**MSOX4022A-01**

**S E R V I C E N O T E**

4000 X-Series Scopes

**A replacement of the power supply cover is needed when the cabinet assembly is replaced.**

Old revision cabinet

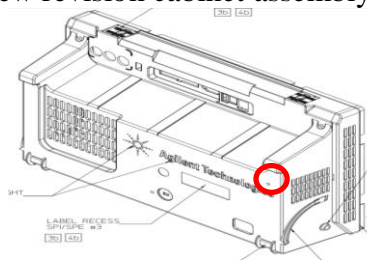
1. If the cabinet assembly (54709-64401) needs to be replaced, check if it is the old revision or the new revision
  - a. Old revision has 3 screw holes
  - b. New revision has 4 screw holes

2. If the cabinet assembly is the new revision, proceed with repair as normal
3. If the cabinet assembly is the old revision
  - a. Replace the power supply cover (54695-00103) with new revision
  - b. Replace cabinet assembly as usual (54709-64401)
  - c. Insert screw (0515-0380) into the new screw hole on the cabinet assembly (circled below)
